**CITY OF LOUISVILLE  
STARK COUNTY, OHIO**

**METZGER PARK BASEBALL & SOFTBALL FIELDS**

**ADDENDUM #1**

**THRASHER PROJECT #101-T30-11111**

SHEET No.  
**11**

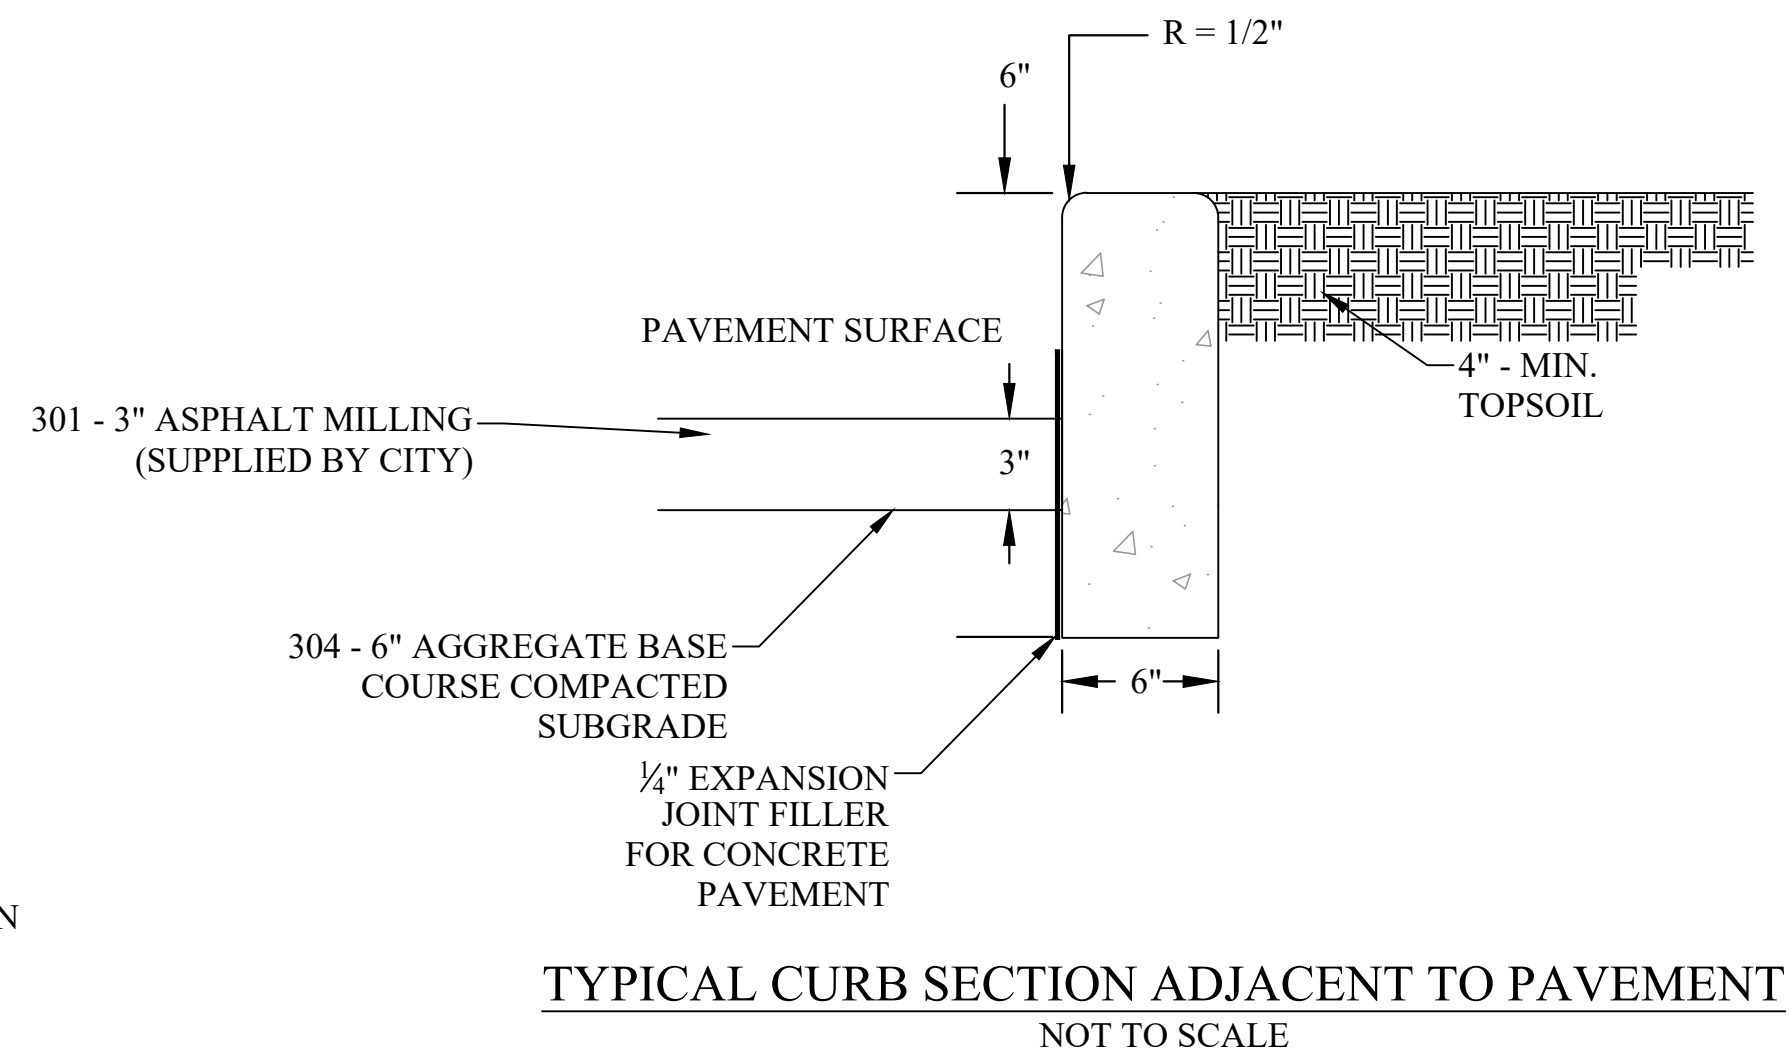
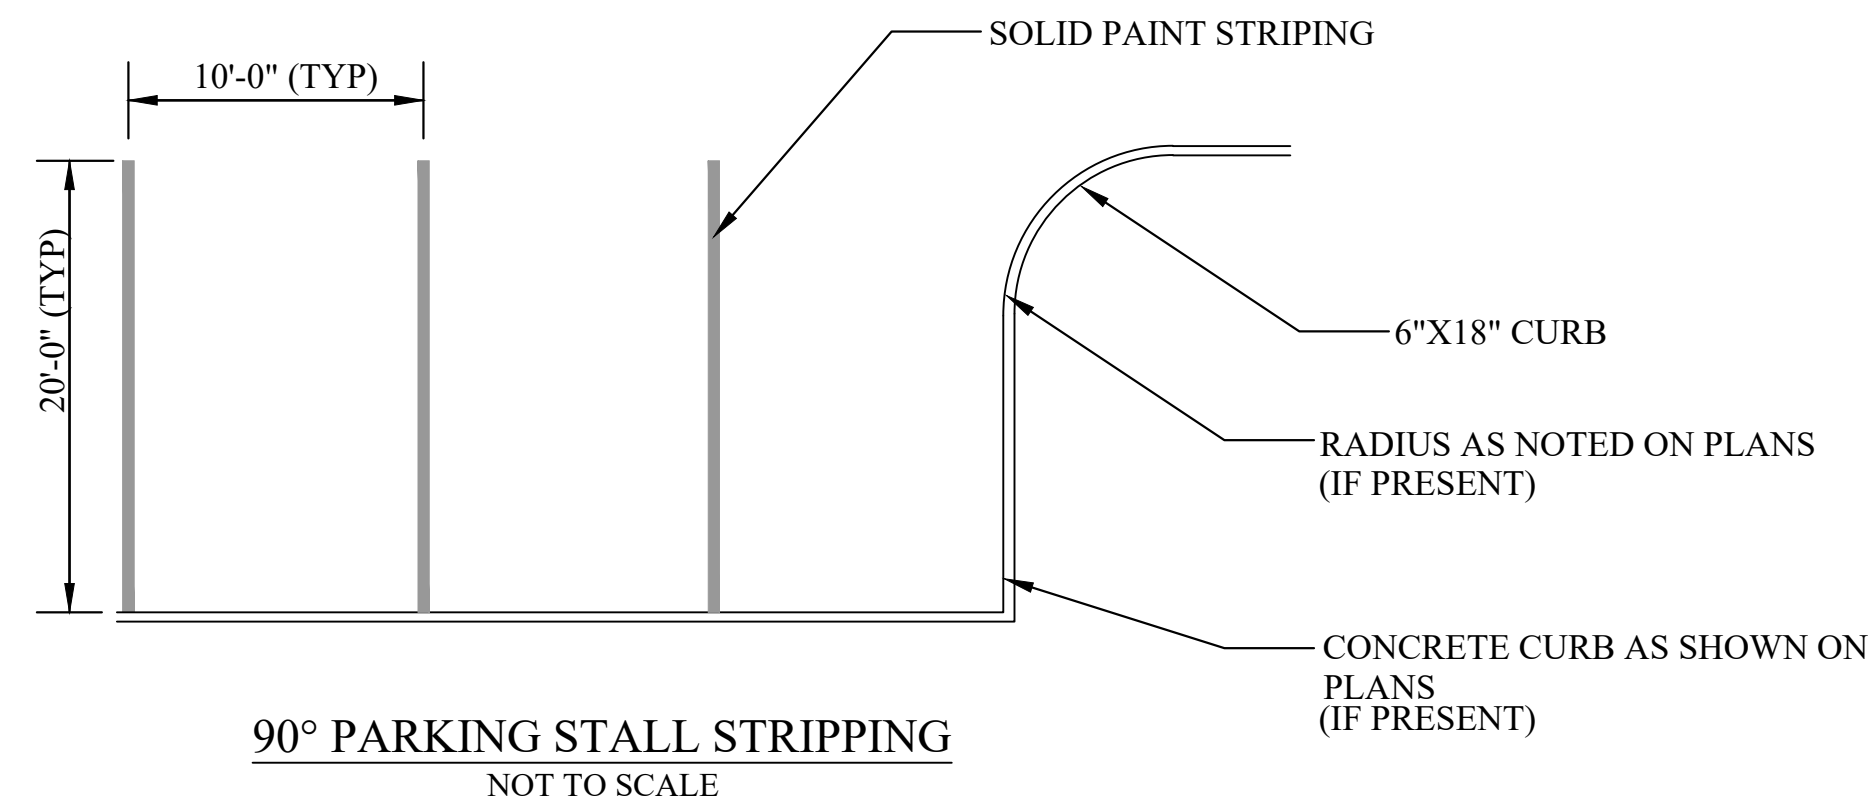
4. Will it be the responsibility of the contractor to furnish loading, trucking, placing, grading and compaction of the asphalt millings provided by the city?

**Yes, the loading, trucking, placement, grading, and compaction of the asphalt millings provided by the city are the contractor's duty. Please reference Sheet 11.**

PHASE 1: CONTRACTOR TO REMOVE TOPSOIL GRADE AND COMPACT SUBGRADE PLACE 304. INSTALL ALL CURB, FURNISH LOADING, TRUCKING, PLACING, GRADING, AND COMPACTION OF 3" OF ASPHALT MILLING SUPPLIED BY CITY.

ACCESSIBILITY SIGNAGE  
 NOT TO SCALE

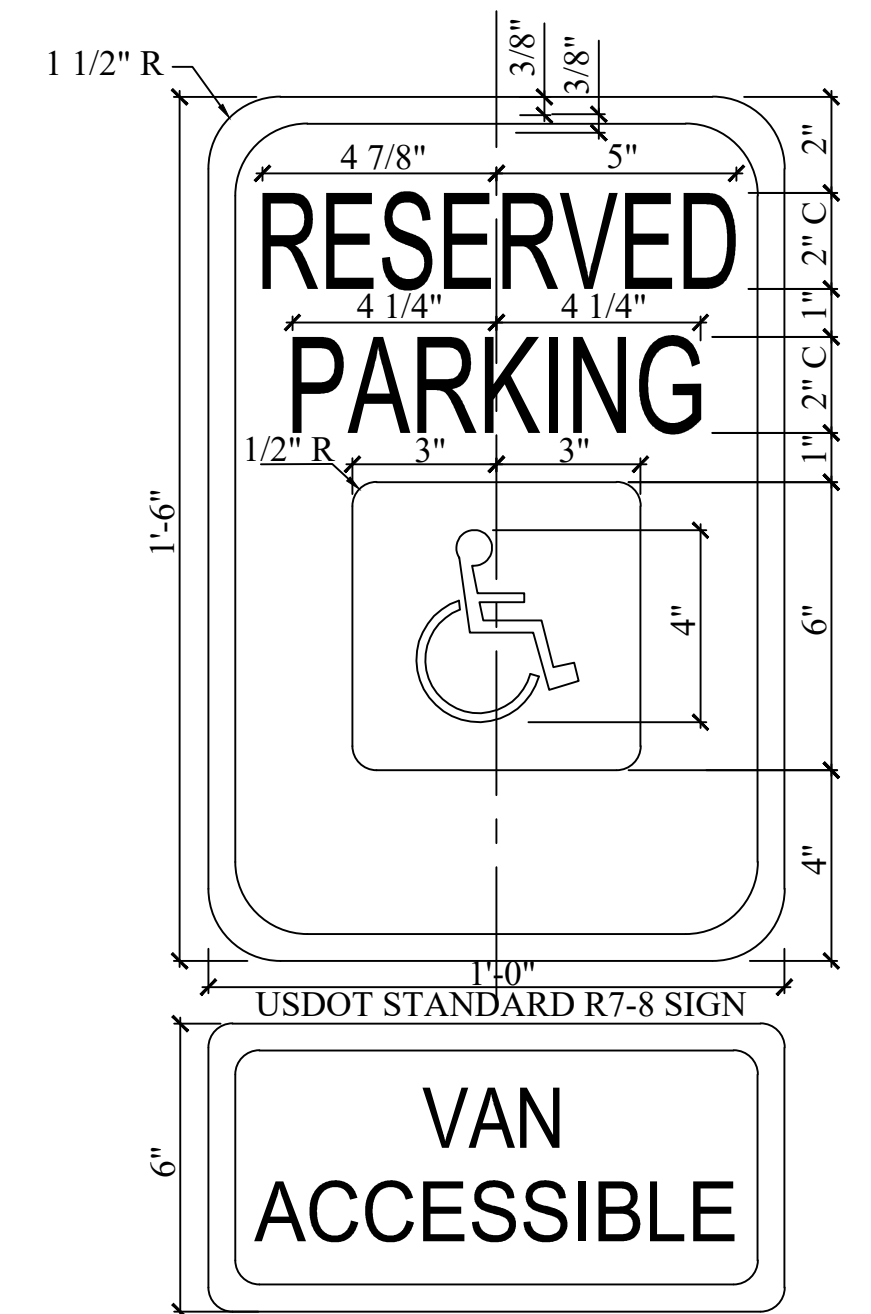
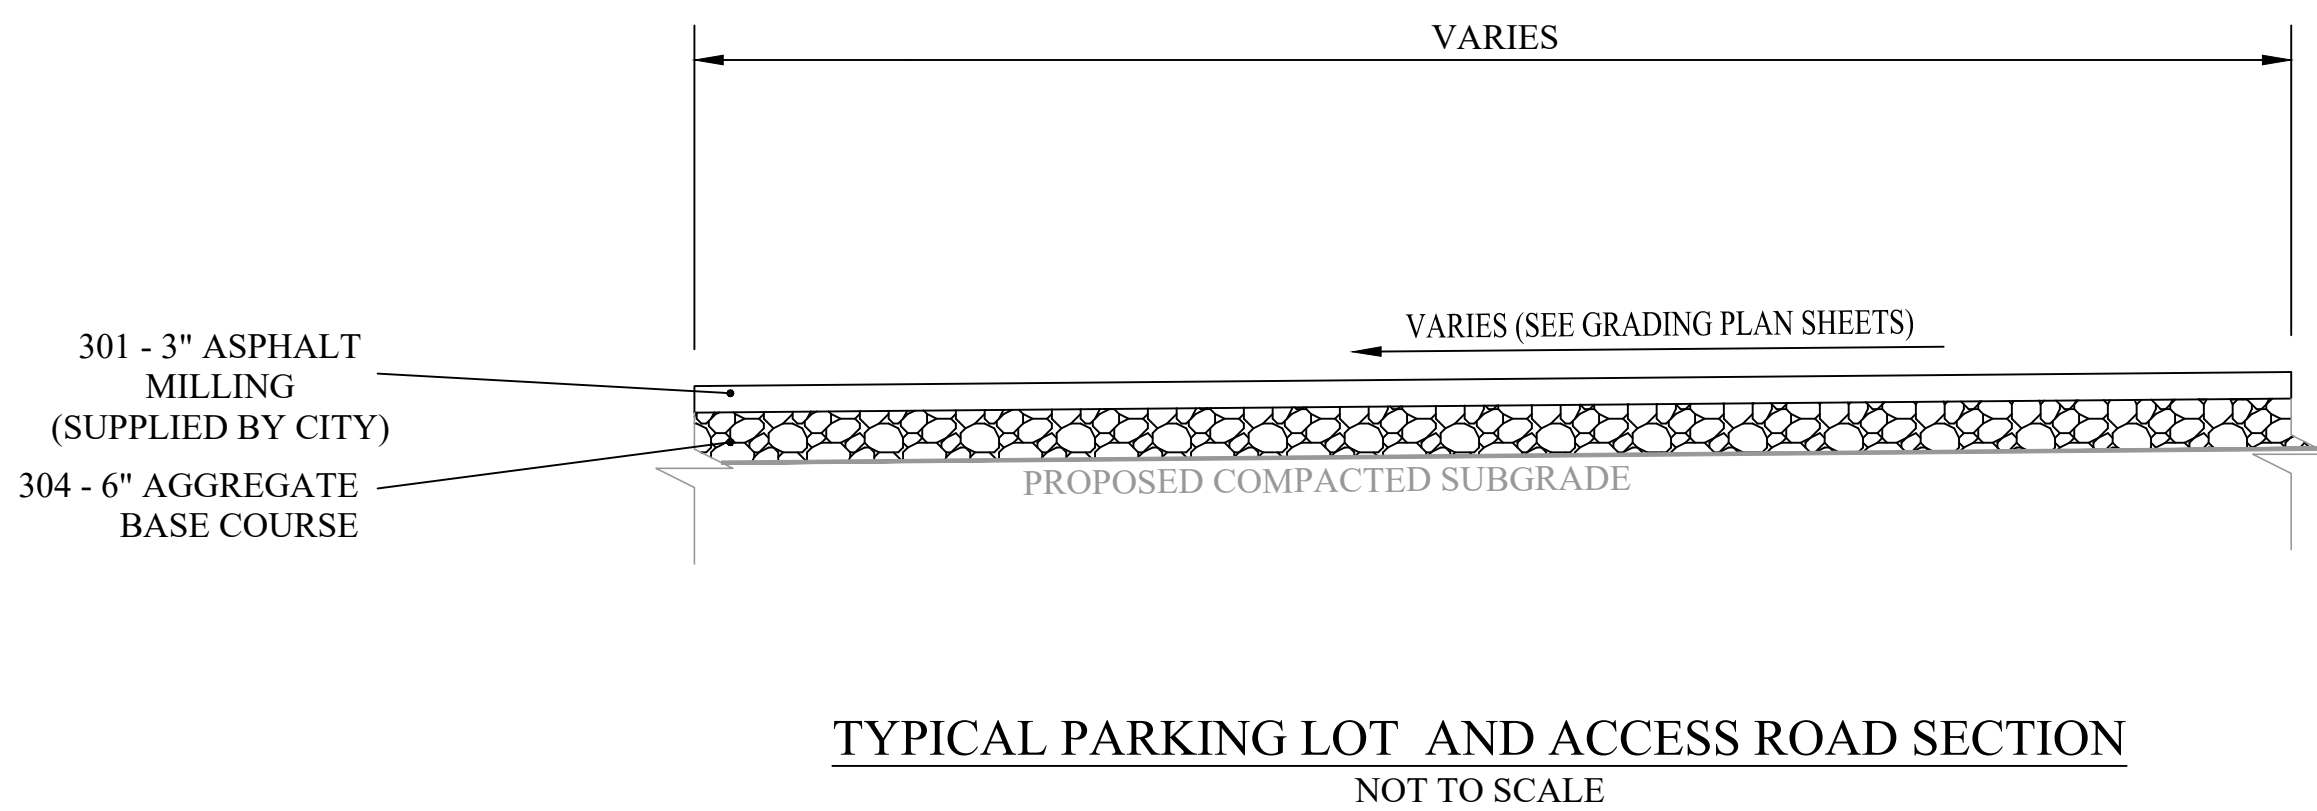
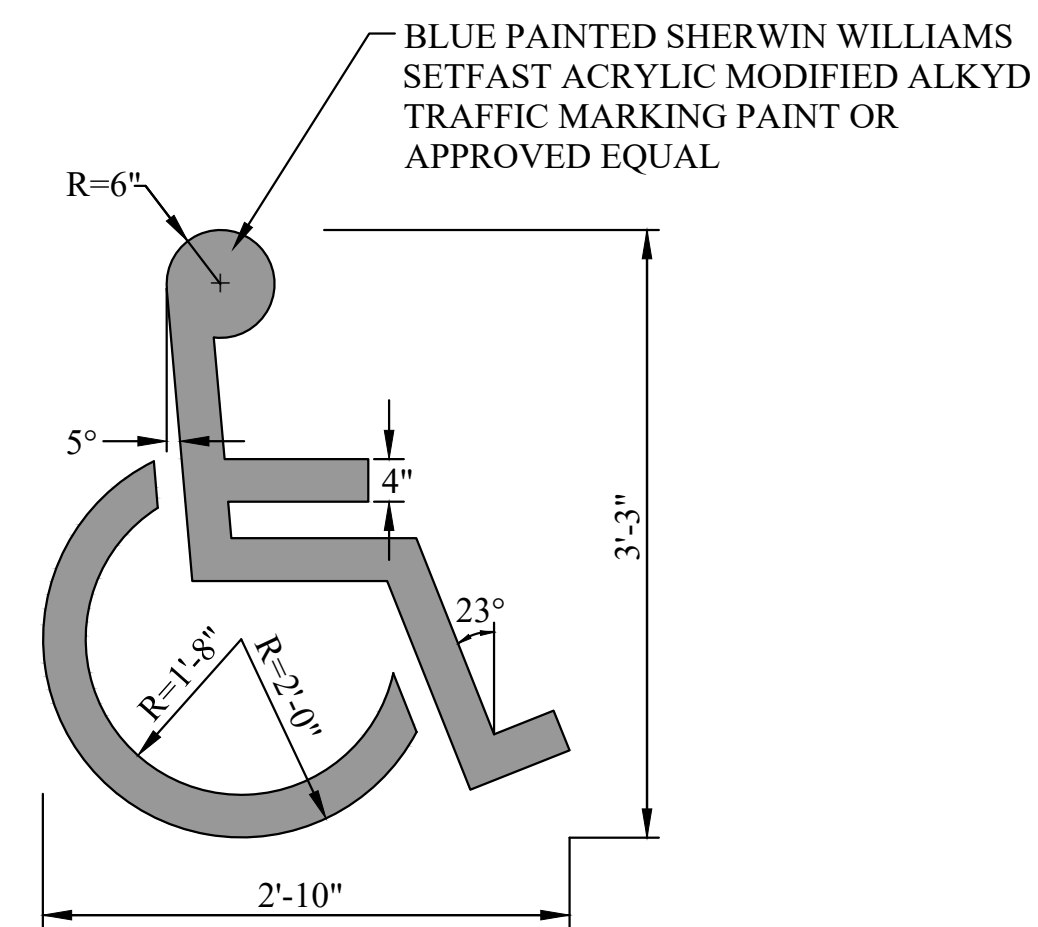
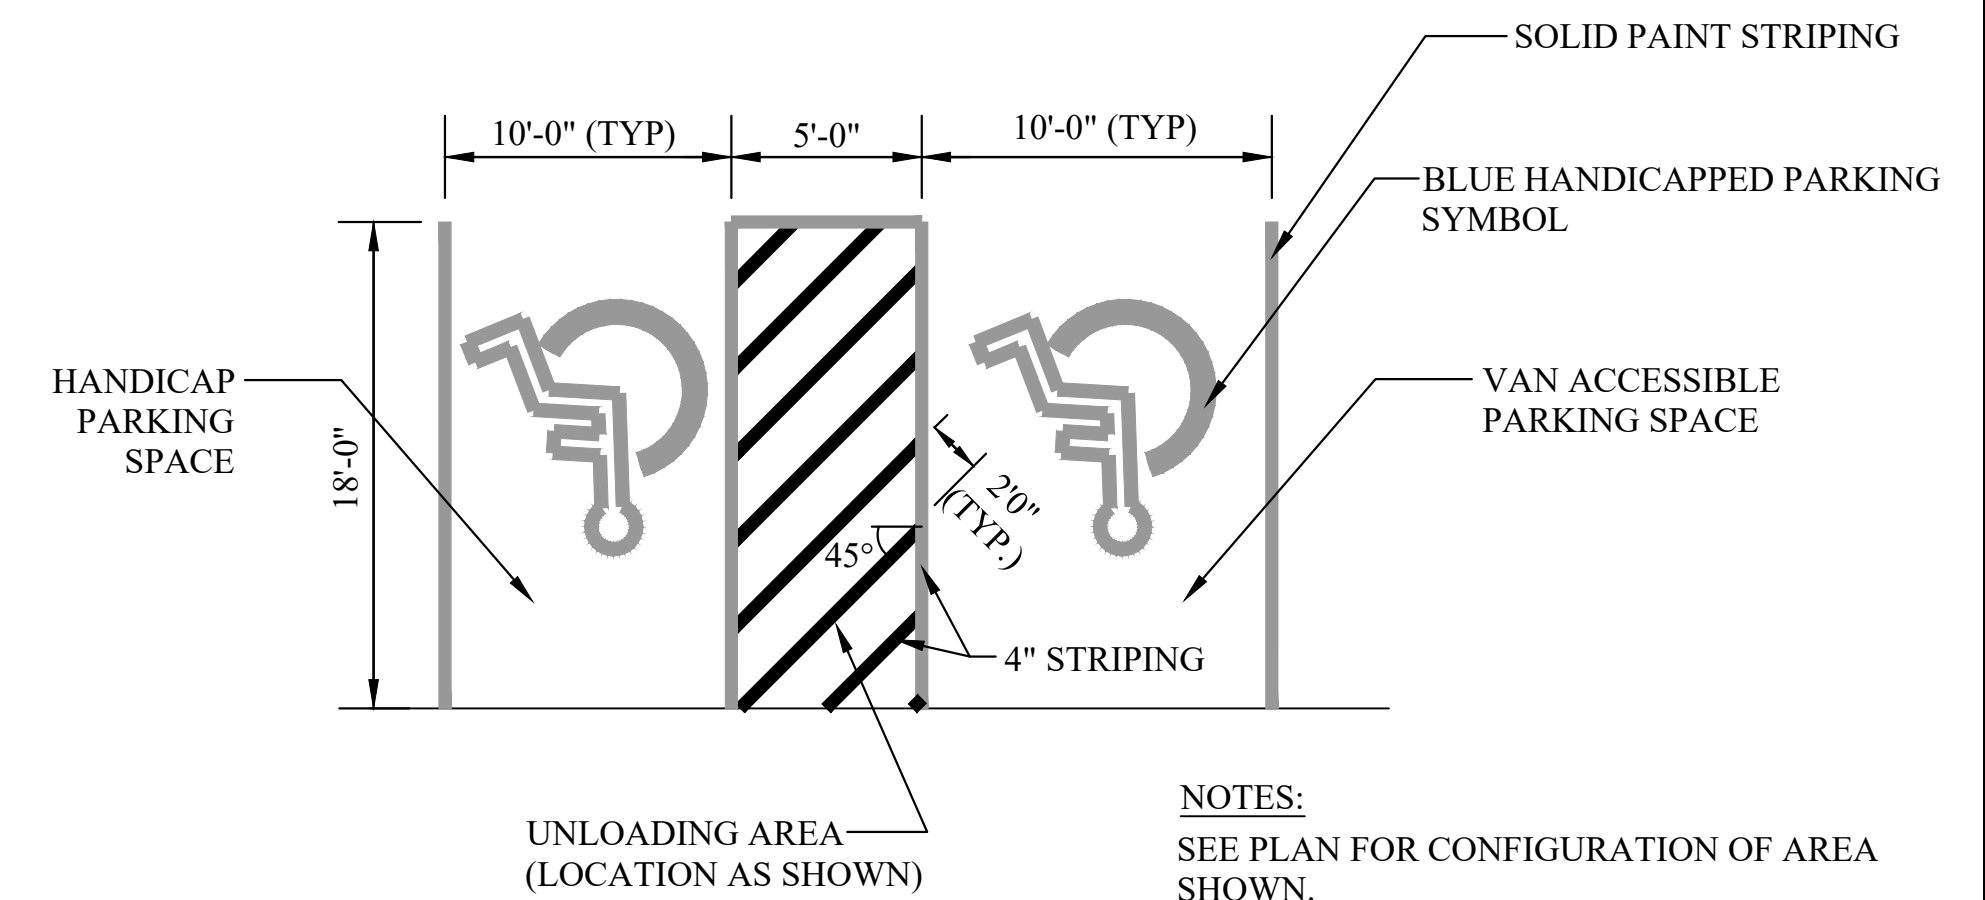
- b. Referencing Sheet 25 the details indicating "PARKING STALL STRIPING" "ACCESSIBILITY SIGNAGE" "HANDICAP VAN ACCESSIBLE PARKING" "INTERNATIONAL HANDICAP SYMBOL" All of these areas do not appear to have an allocation on the BID SCHEDULE. How should that be interpreted? Is this item to be considered a non-perform item?

**The bid schedule has been updated and Sheet 25 has been revised.**

TYPICAL PARKING LOT AND ACCESS ROAD SECTION  
 NOT TO SCALE

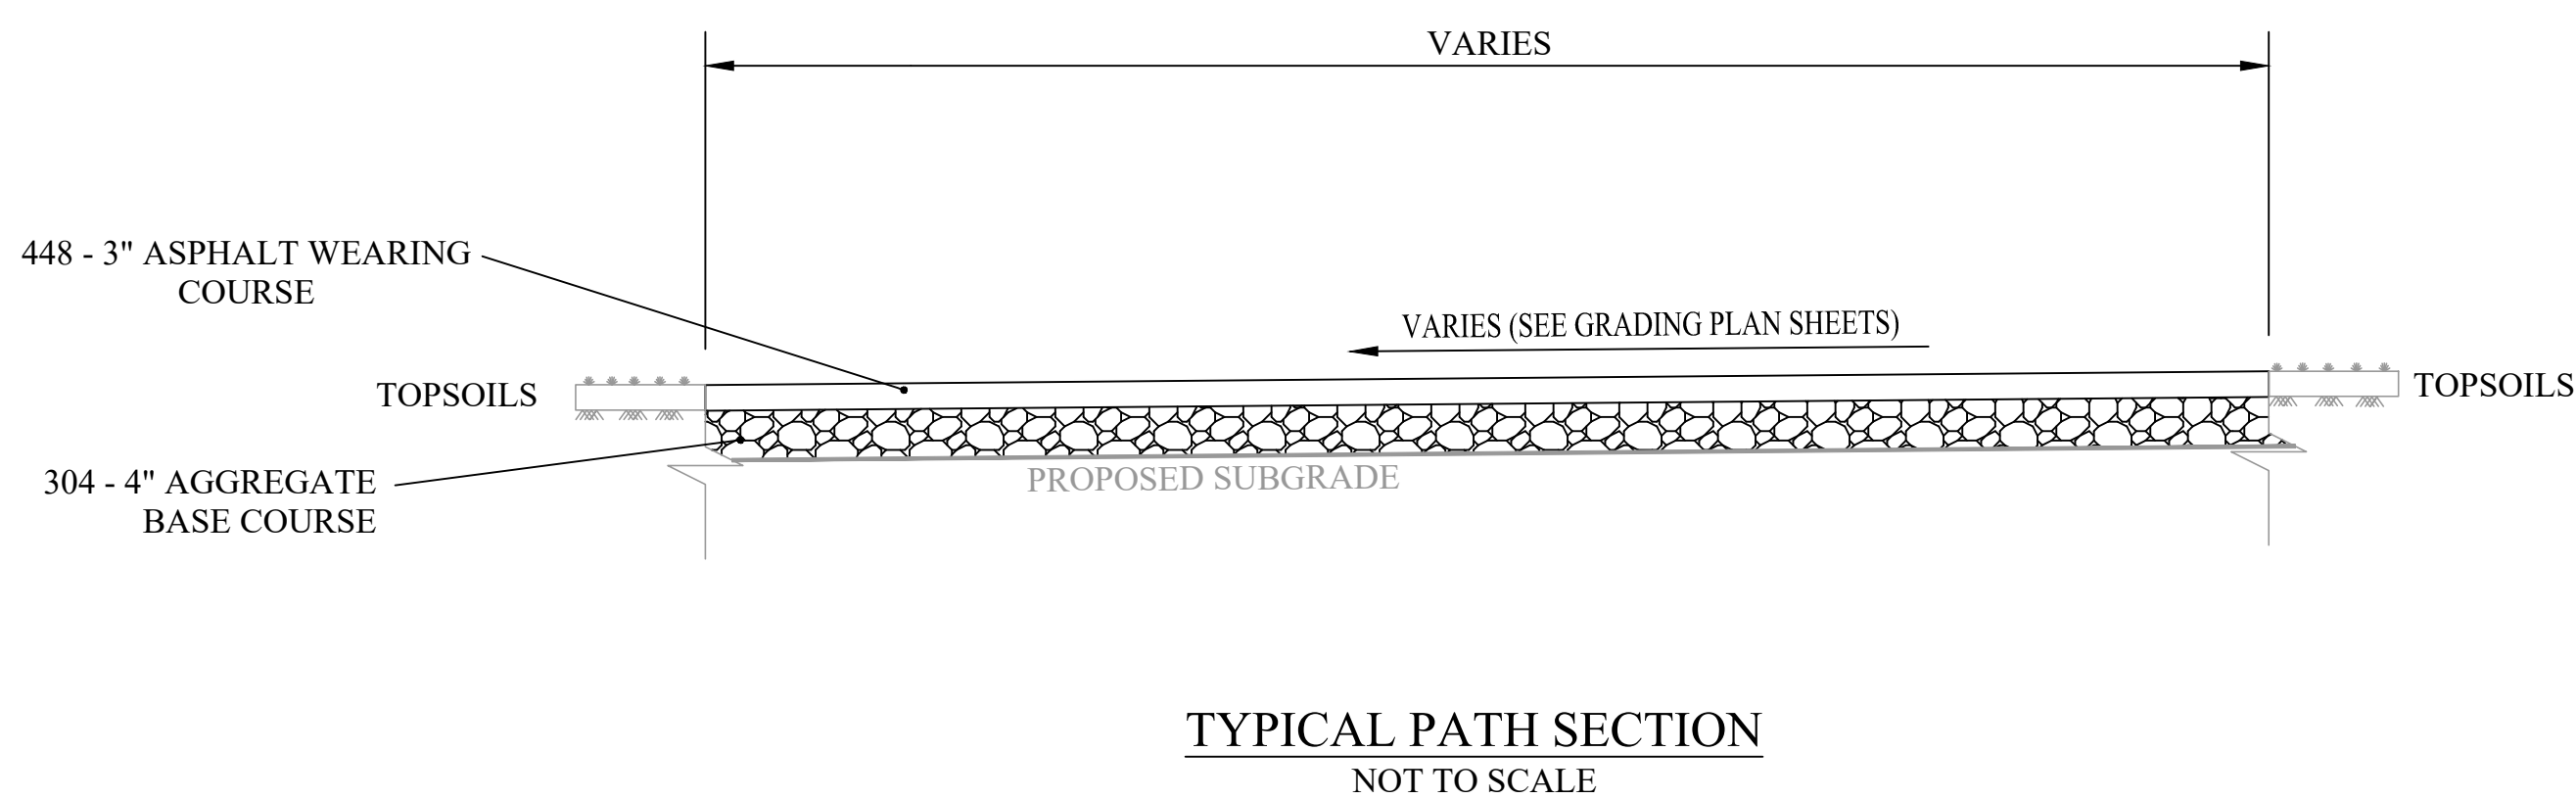
1. Referencing Sheet 6 "Site Plan 1" a 6"x18" CONCRETE CURB is indicated on the drawings and the referenced detail on sheet 25 indicates an 8" wide concrete curb. Which Curb detail should be constructed?

**The details on Sheet 25 have been updated to reflect that the concrete curb should be 6".**
